CITY PROJECT # 07-24

PALM SPRINGS ANIMAL CARE FACILITY

ADDENDUM NO. 1

REVISED PHOTOVOLTAIC PANEL SITE PLAN - ADDITIVE ALTERNATE #14

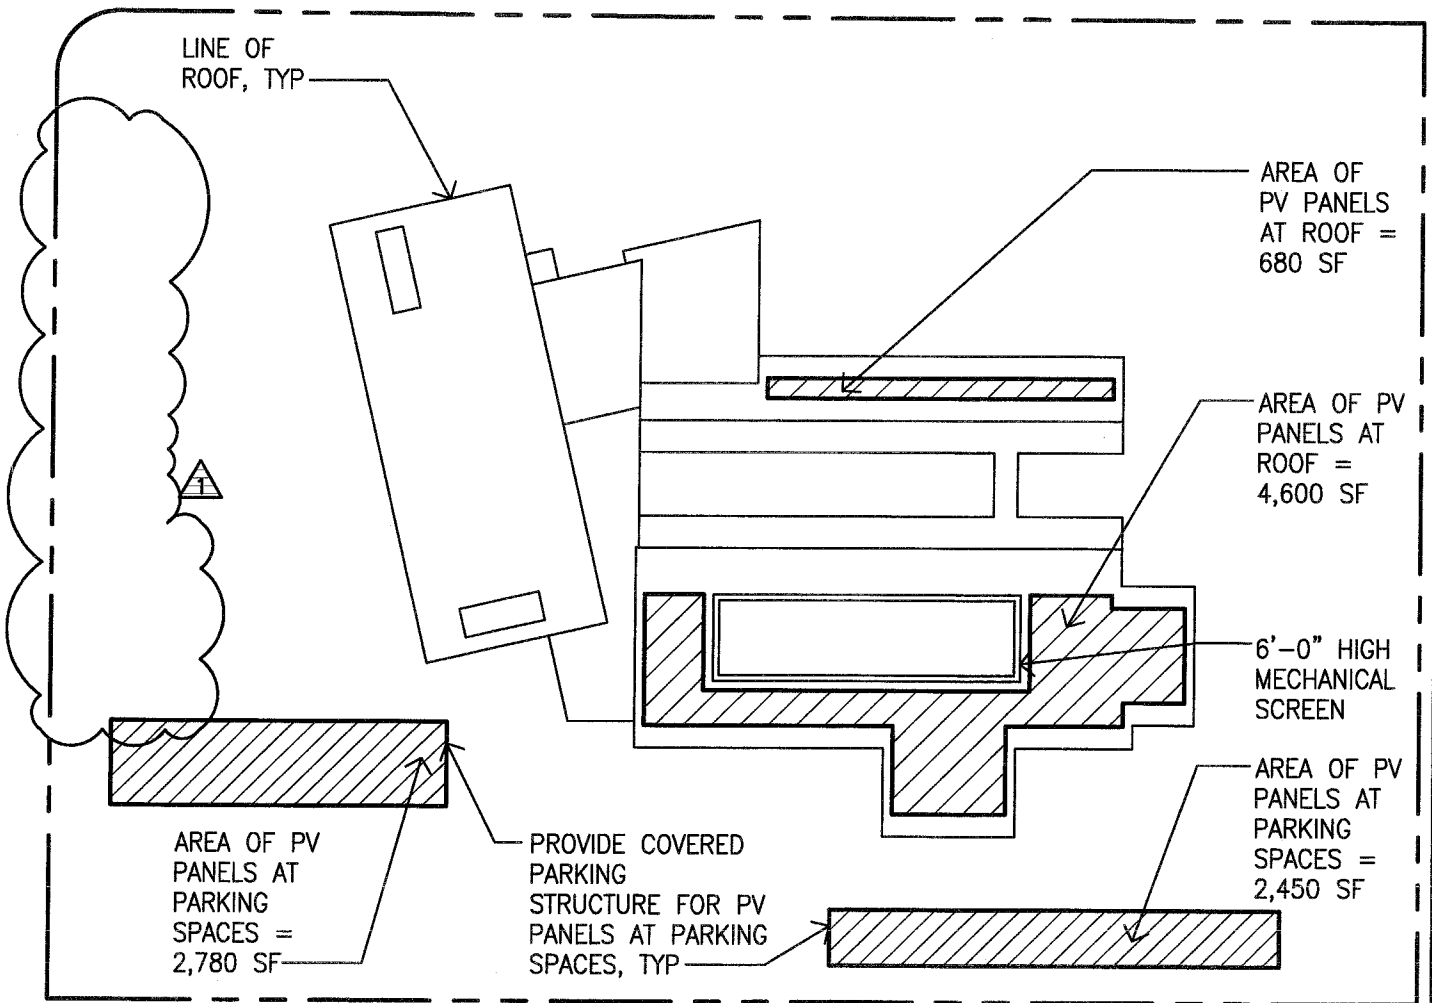
26. **A1-A1:** Revised Photovoltaic Panel Site Plan – Additive Alternate 14.
27. **A1-A2:** Eliminate concrete path on East Side of Building.
28. **A1-A3:** Revised Detail 16 on A3.11 Adding Dog Door and Exterior Removable Acoustic Panel

TOTAL AREA OF PHOTOVOLTAIC (PV) PANELS AT ROOF & PARKING SPACES = APPROXIMATELY 14,310 SF

NEW DETAIL II ON A9.12 EXTERIOR REMOVABLE ACOUSTIC PANEL - PLAN VIEW

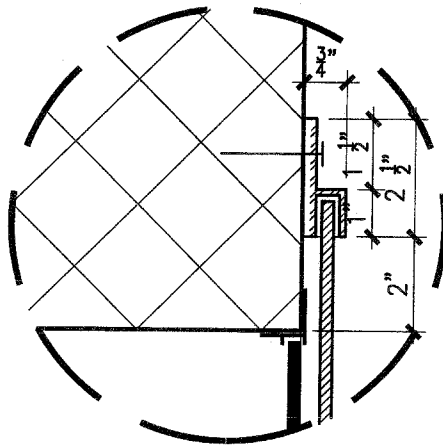
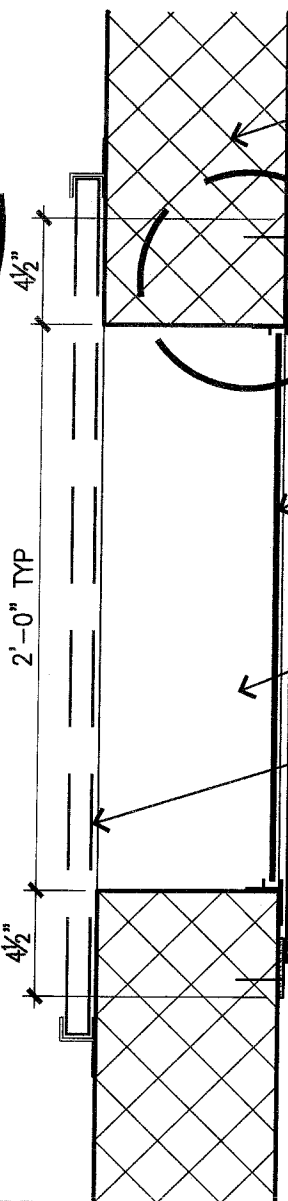
29. **A1-A4:** New Detail 11 A9.12 Exterior Removable Acoustic Panel – Plan View.
30. **A1-A5:** New Detail 12 on A9.12 Exterior Removable Panel – elevation view.

- 8" EXTERIOR CMU BLOCK WALL
- GALV MASONRY WALL ANCHORS TO SECURE TRACK AT 8" O.C. TYP. PAINT TO MATCH TRACK
- PAINTED GALV MTL TRACK, EXTEND 5" ABOVE AND BELOW OPENING CORNERS, PROVIDE CAP/STOP AT BOT OF TRACK TYP. AT ALL OPENINGS
- REMOVEABLE FIBERGLASS PANEL, ONE ONLY SEE DETAIL 12/A9.12
- CUSTOM EXTERIOR DOG KENNEL DOOR BY SECUTIRY BOSS MANUFACTURING WITH NYLON REINFORCED FLAP AND HEAVY DUTY FRAME CUSTOM FIT TO OPENING, TYP. AT ALL OPENINGS
- CONC CURB BELOW
- GUILLOTINE DOOR SYSTEM BY "T-KENNEL", TYP. OPCI

A1-A7

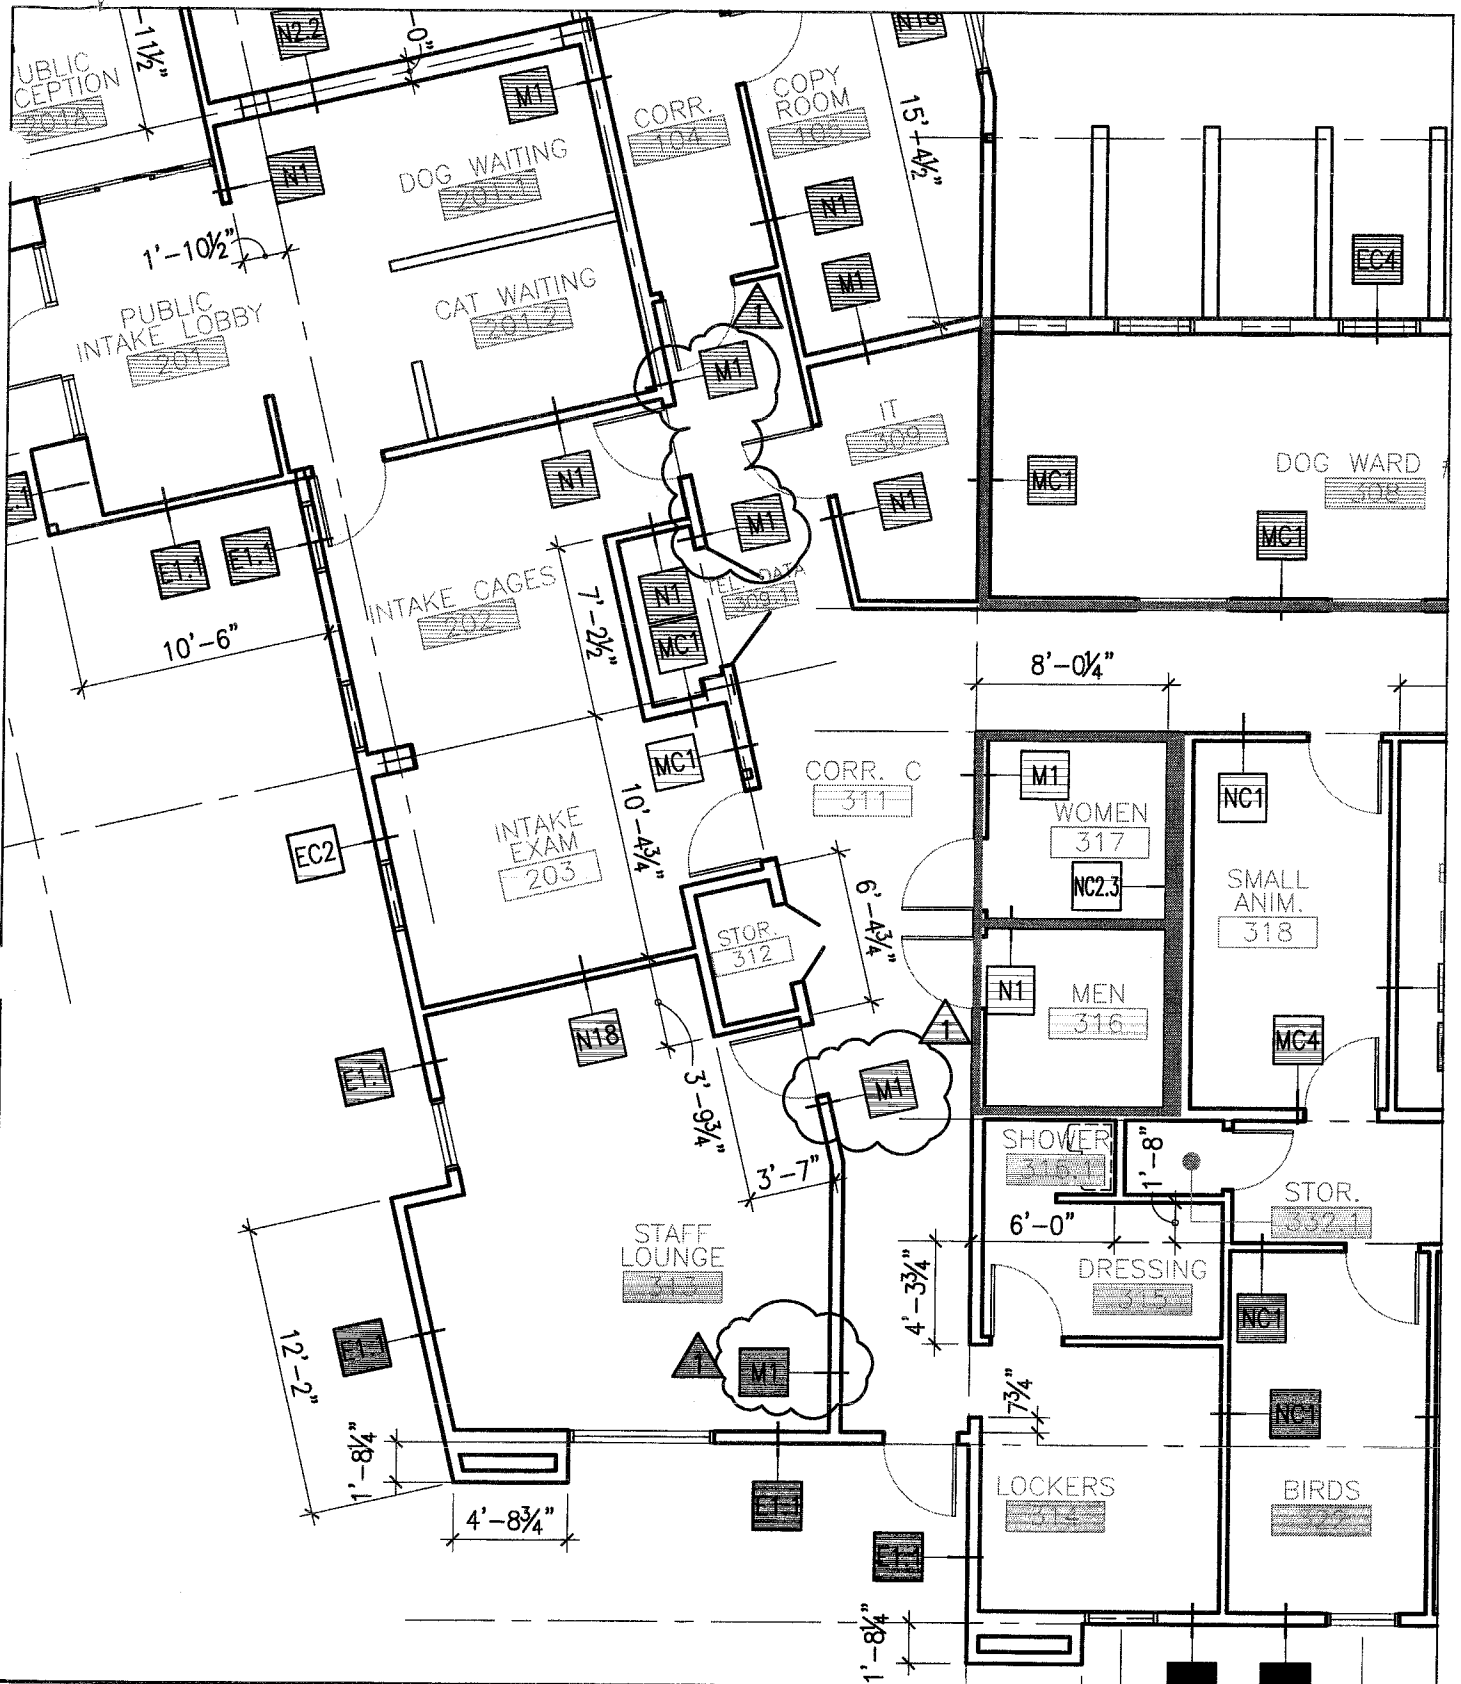
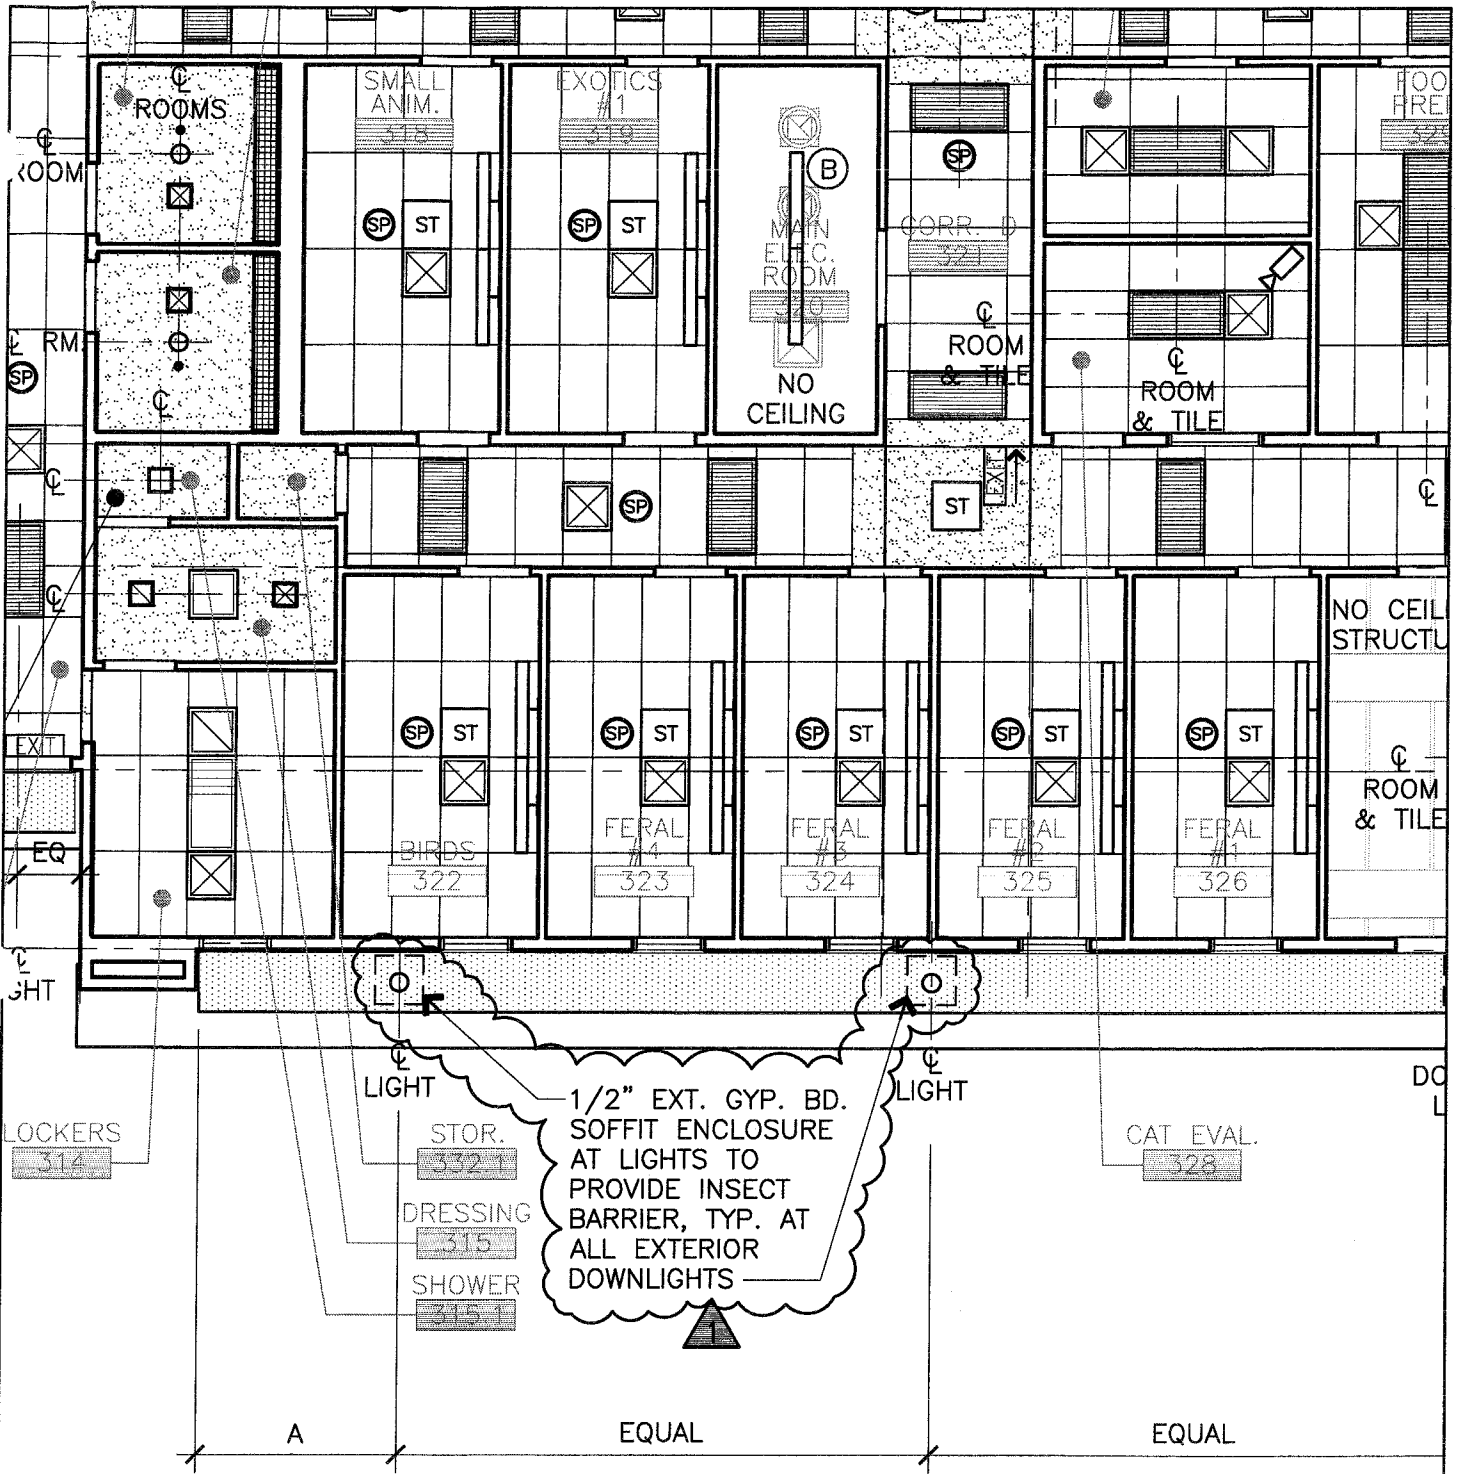
31. **A1-A6:** Revised Wall Type at Corridor C From Wall Type N1 to M1.
32. **A1-A7:** Added Gate Hardware Groups to Schedule on A10.23.
33. **A1-A8:** Added Note to Provide ½" Gypsum Board Enclosure at all exterior under soffit down lights.

1 SOLID STEEL METAL PANEL GATE

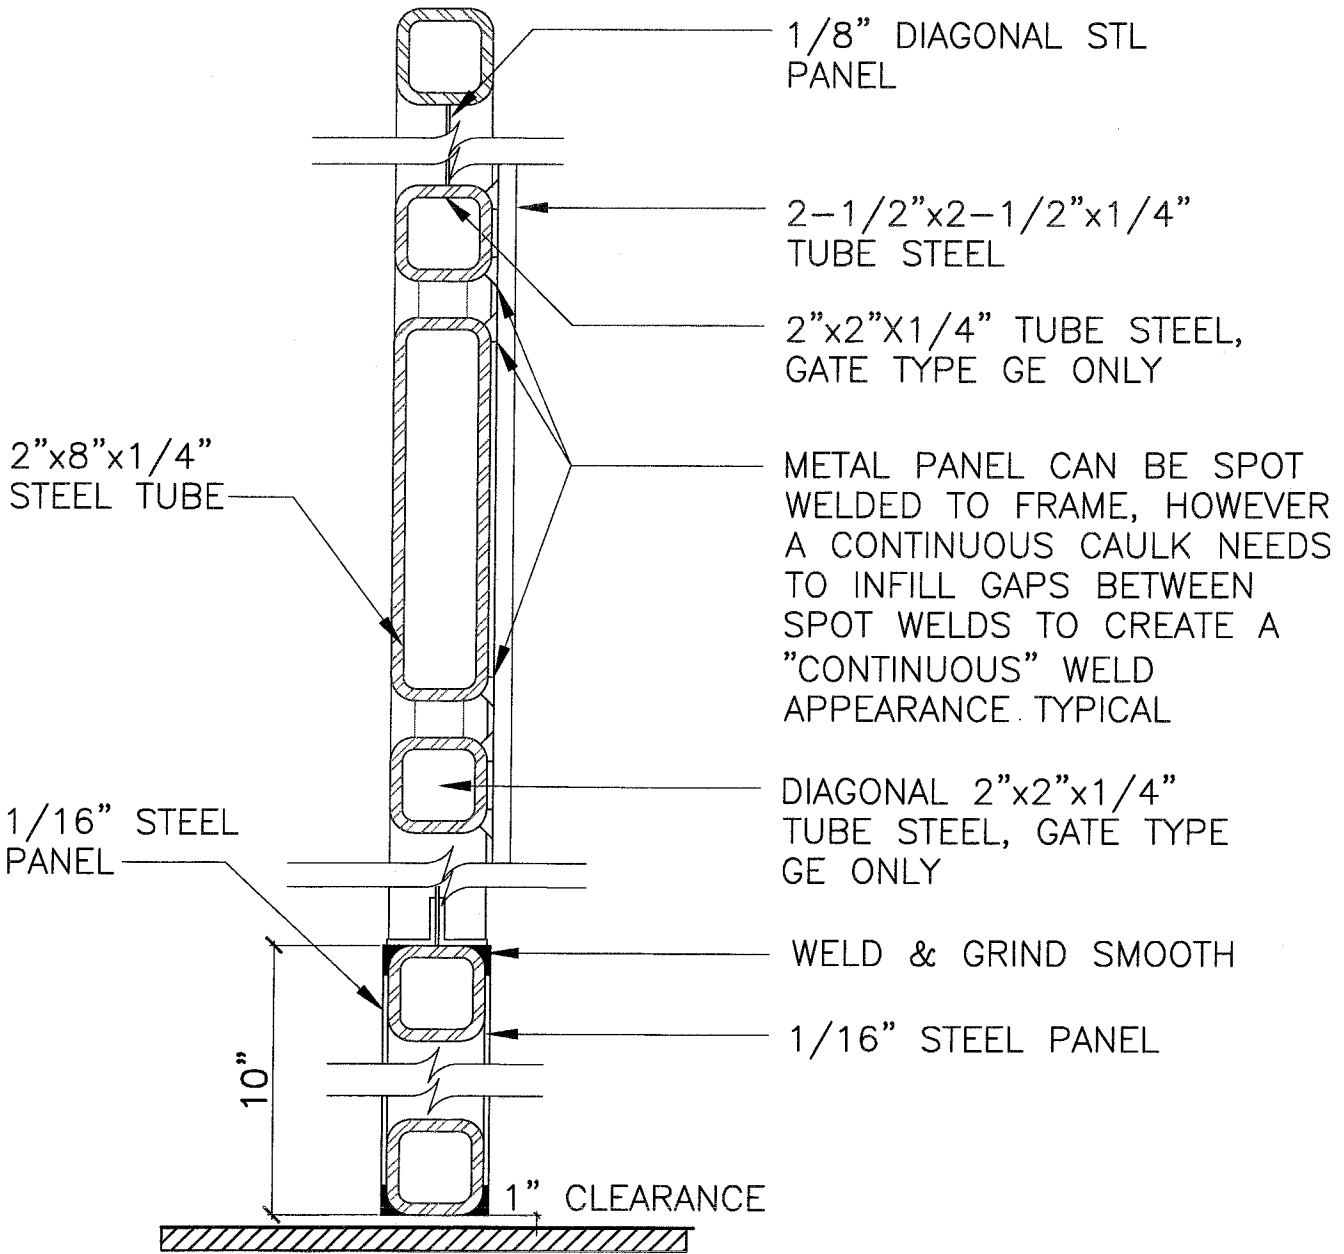
34. **A1-A9:** Added Detail Tag at solid steel panel gates on A10.23.
35. **A1-A10:** New detail at solid steel panel gates, Detail 1 A10.23.
36. **A1-A11:** Provide Wall Backing for future upper cabinet installation at Surgery Room #356.
